**Regarding: 13V-298**

### 2014 XVS95CE(C) MODELS

### FACTORY MODIFICATION CAMPAIGN – Wire Harness Routing

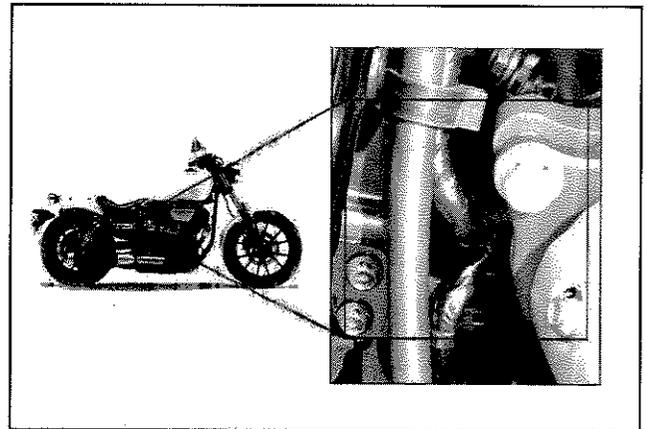
Yamaha Motor Corporation, U.S.A. has decided that a defect which relates to motor vehicle safety exists in certain 2014 XVS95CE/C "Bolt" model motorcycles. In affected motorcycles, there is a possibility that the wire harness is routed too close to the rear exhaust area allowing the wire harness to contact the rear exhaust. If this happens, heat from the exhaust could damage the wire harness which could result in engine stalling and the possibility of a crash with injury or death.

To correct this defect, Yamaha is initiating a Factory Modification Campaign. Affected units must have two retaining bands installed to hold the wire harness away from the rear exhaust area after first inspecting to be sure the wire harness has not been damaged.

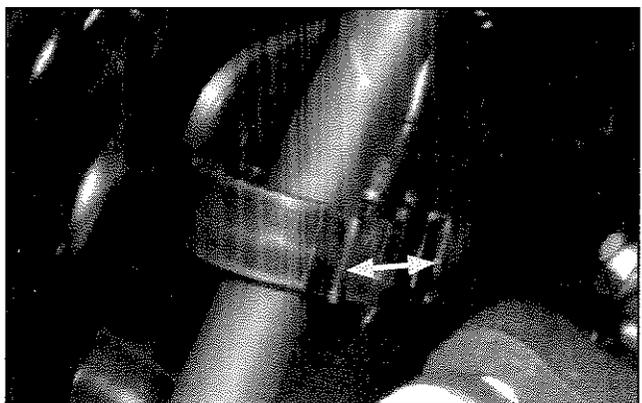
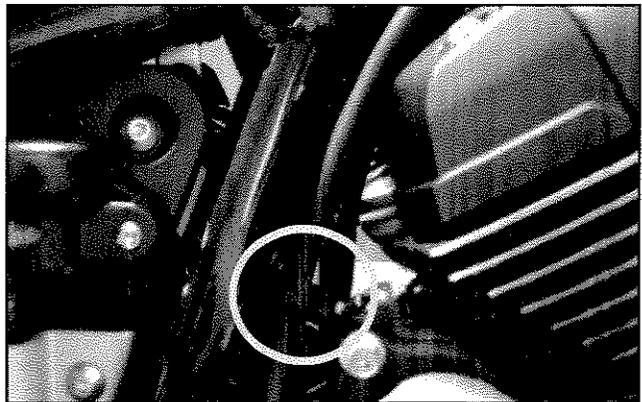
1. Make sure the engine is cold. If engine temperature is hot, allow the engine to cool before attempting this modification. Set the engine stop switch to "OFF" position to prevent engine start.
2. On sold units, check the wire harness for heat damage. If any damage is found, replace the wire harness assembly following the procedures in the XVS95CE(C) Service Manual (LIT-11666-27-30).
3. Release the clutch cable clamp (see adjacent photos).

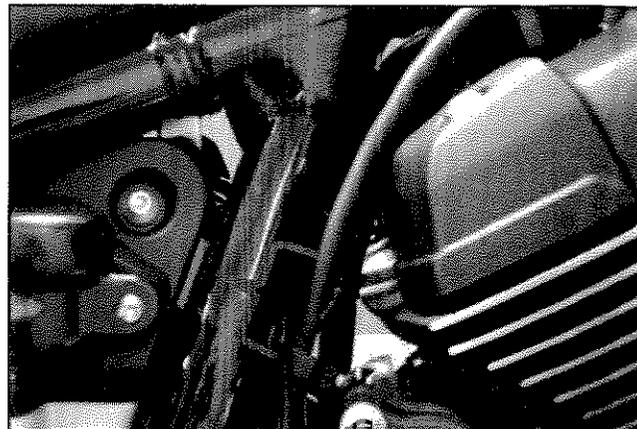
4. Take up the slack of the wire harness from the upper side of the clutch cable clamp by gently pulling it downward. Be sure the wire harness does not come into contact with the engine.

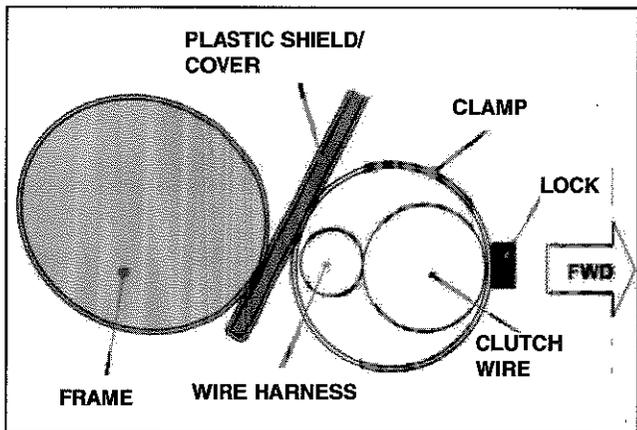
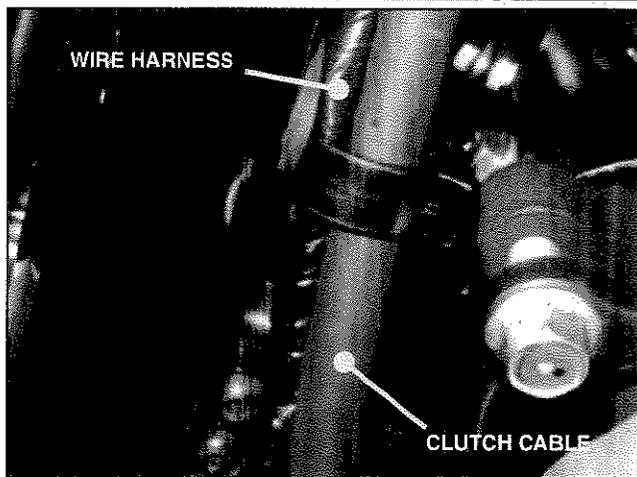
5. Route the clutch cable forward in the clutch cable clamp so that wire harness is located near the frame as follows.

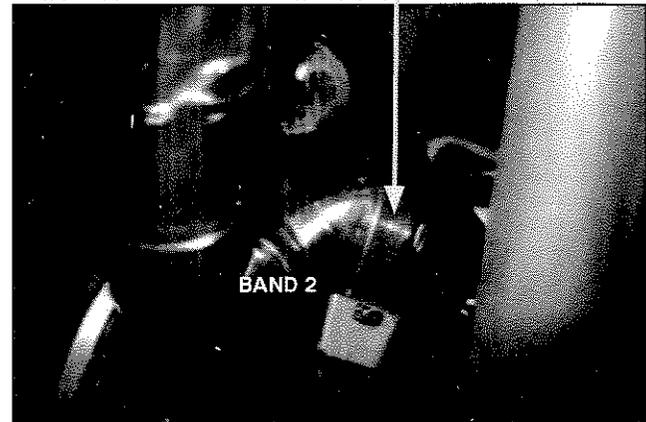
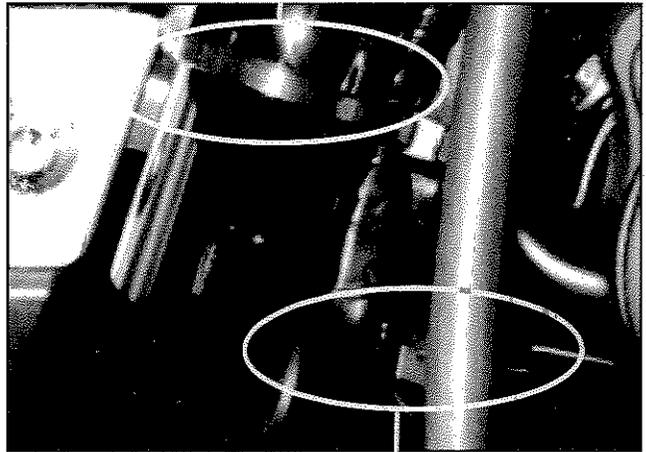
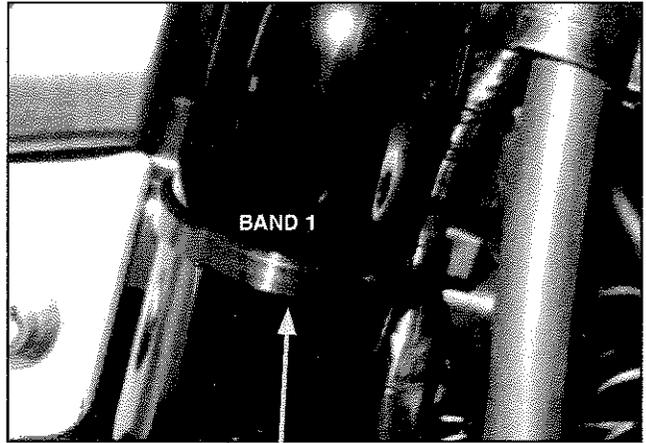
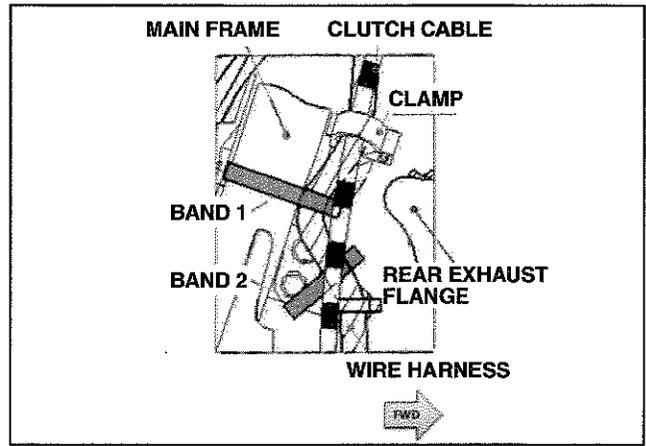
6. Fasten the wire harness to the frame with the new bands from the kit as follows:

7. Starting with "Band 1," confirm that the wire harness follows the frame contour (a), then install and tighten the band to secure the wire harness.

The band is tight when more than 70mm of the end is sticking out of the band's lock (b).

Cut off the extra band (c) and make sure there are no sharp edges that could damage other parts.

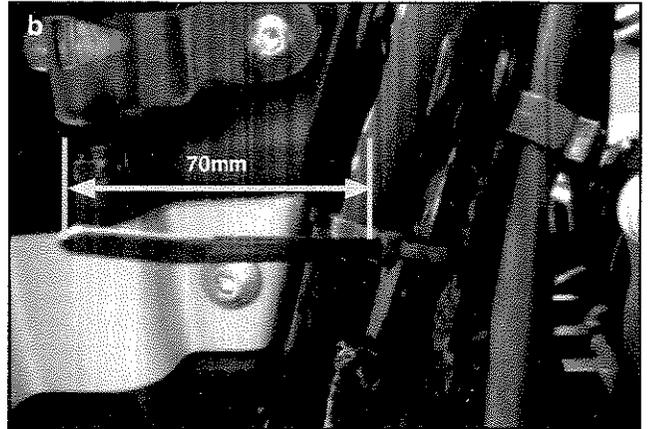
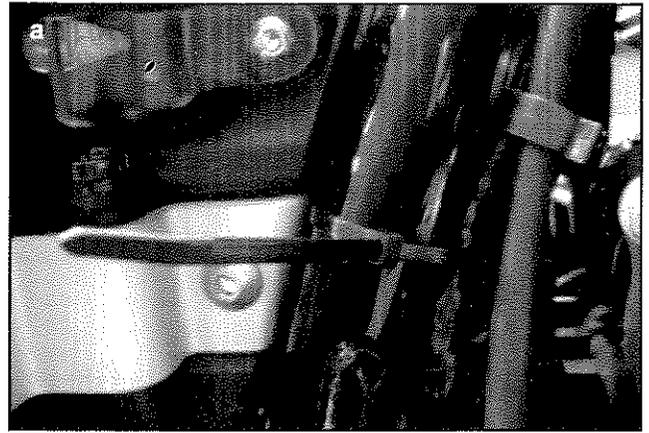
Then rotate the band so its lock is to the inside of the frame (d).

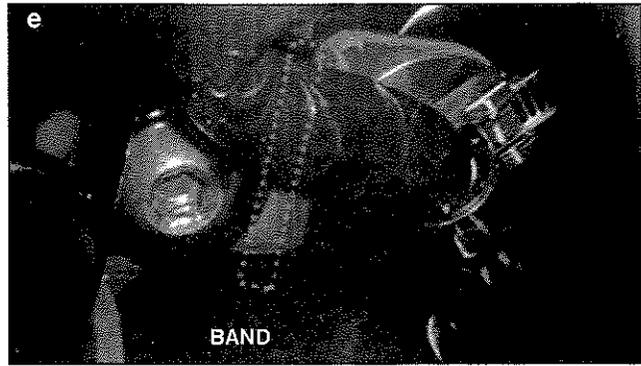
8. With "Band 2" in the groove of the bracket, fasten the wire harness to the bracket (e).

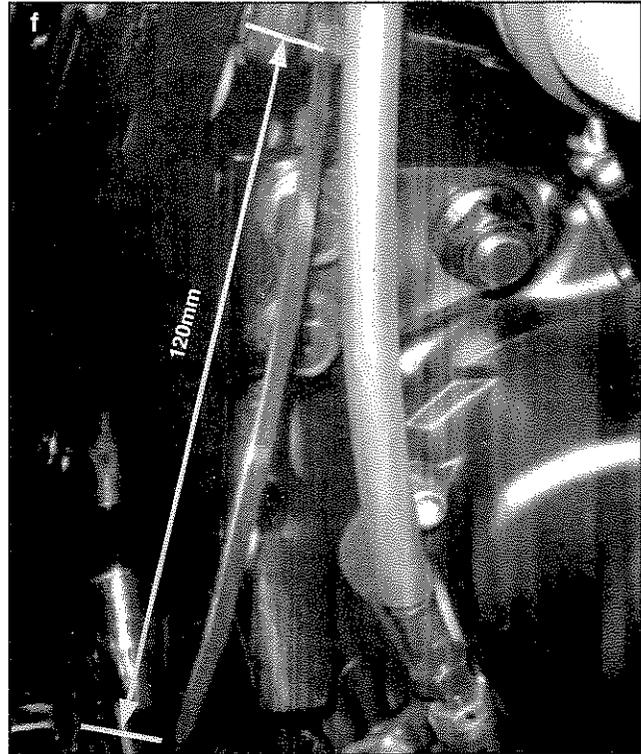
Tighten the band so that more than 120mm of the end is sticking out of the band's lock (f).

Cut off the extra band and make sure there are no sharp edges that could damage other parts (g).

Then rotate the band so its lock is at the bottom of the bracket (h).

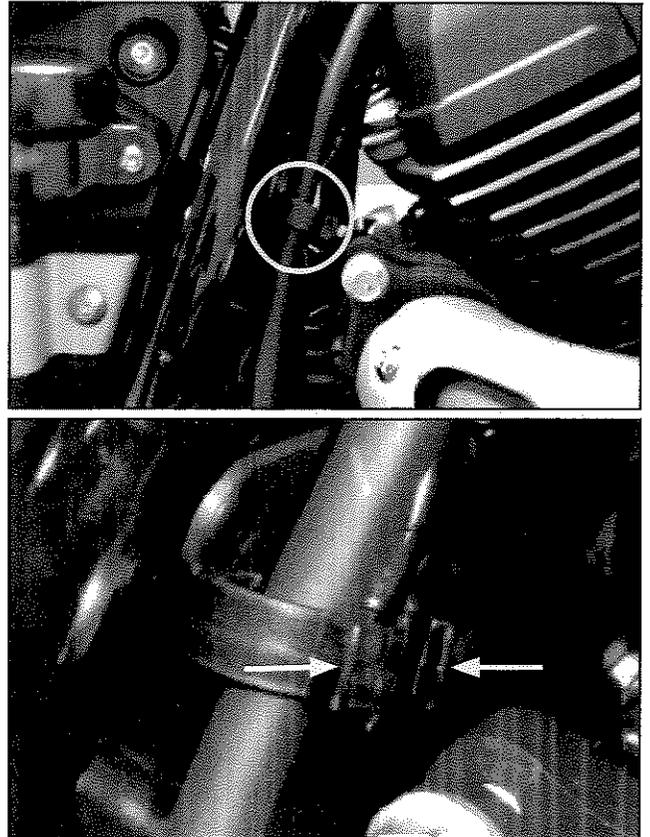
9. Lock the clutch cable clamp again.

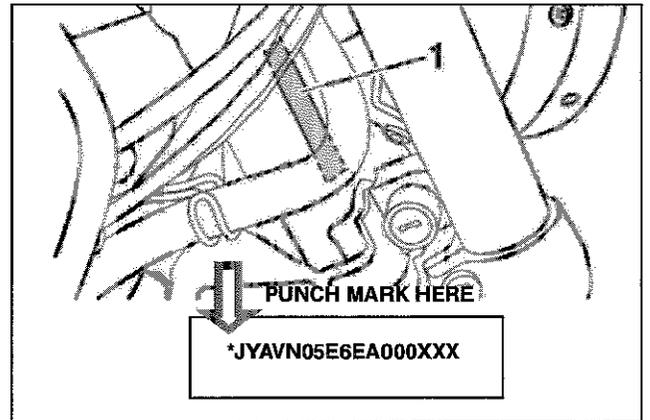
After modifying a unit, make a punch mark above the Vehicle Identification Number (VIN) as shown in the adjacent illustration (1). Check for this punch mark and the additional bands if you encounter an unfamiliar unit. You can also check unit status on YDS or by contacting your Regional Technical Advisor.
